U.S. Department of the Interior

Bureau of Land Management

May 2004

FINAL
ENVIRONMENTAL IMPACT STATEMENT
Desolation Flats Natural Gas Field
Development Project
Sweetwater and Carbon Counties, Wyoming

Figure 3-6. Air Quality Assessment Area

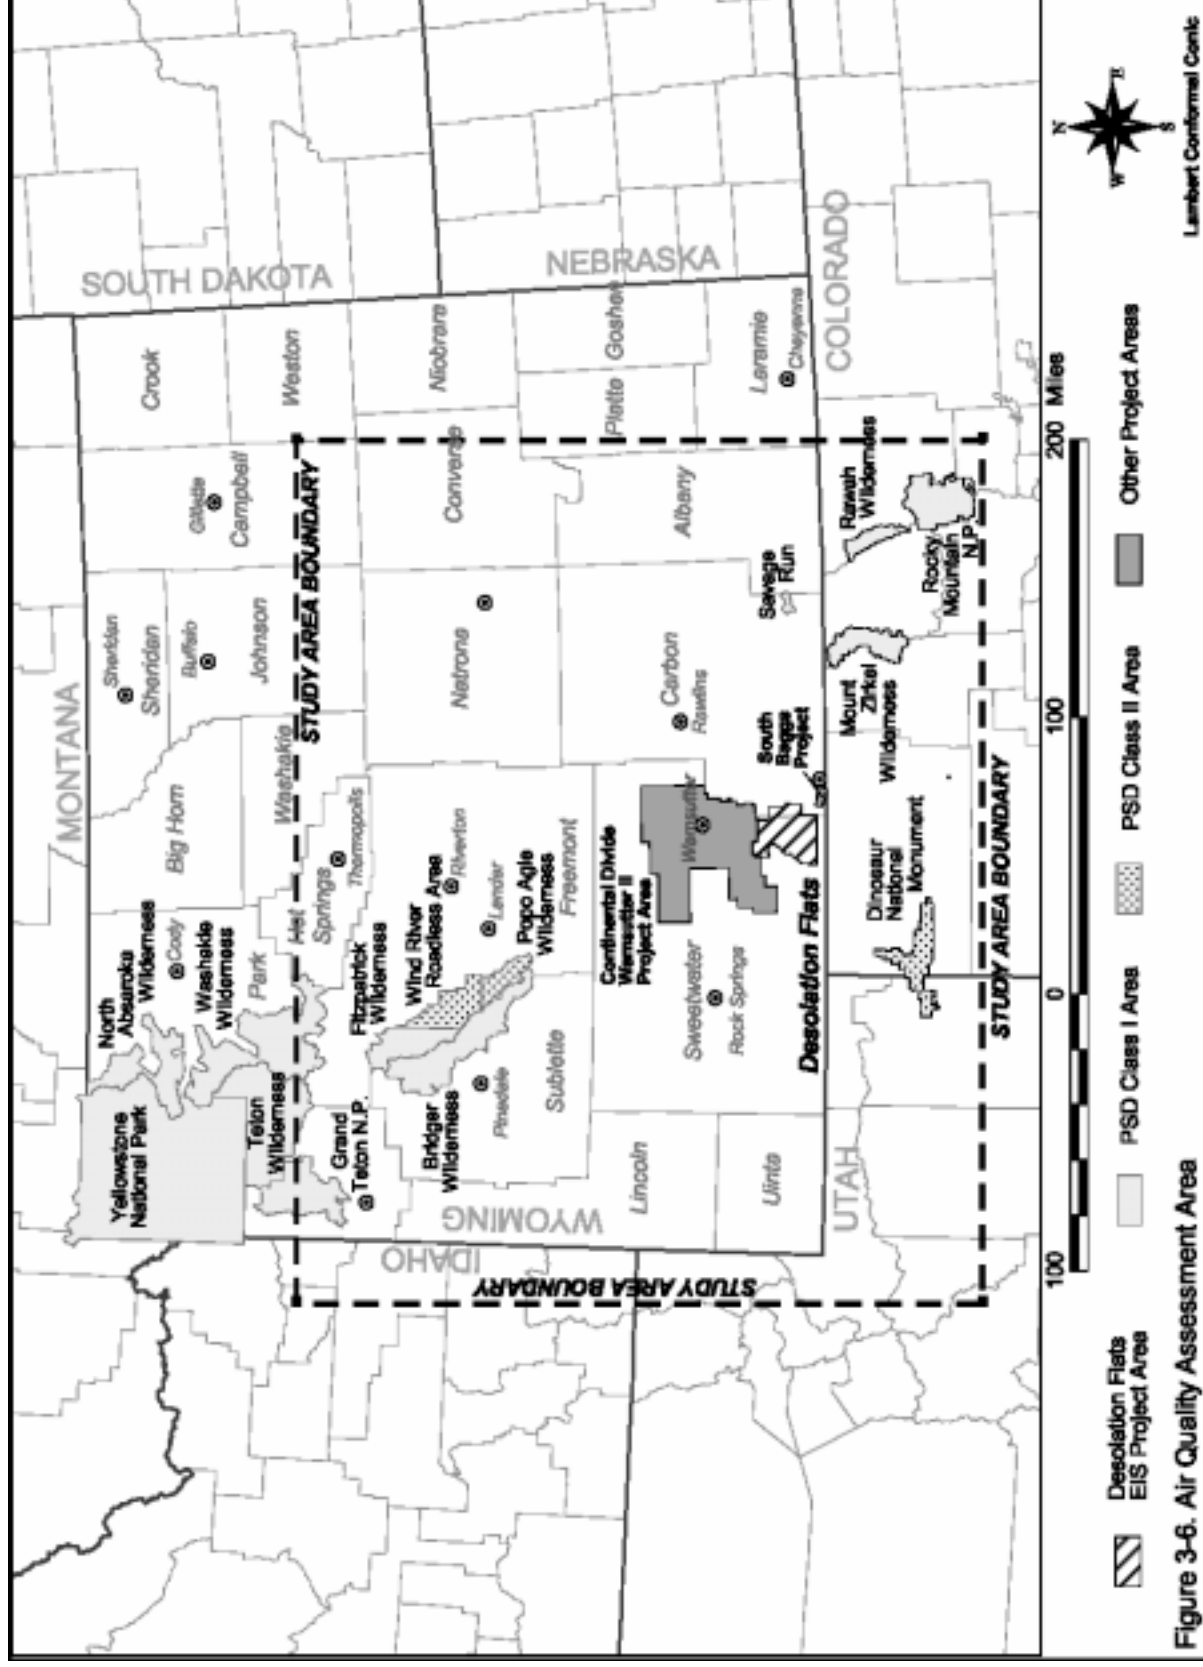
Comment 146-14: Pg 3-22 fig. 3-6 Revise map with additional Class I areas.
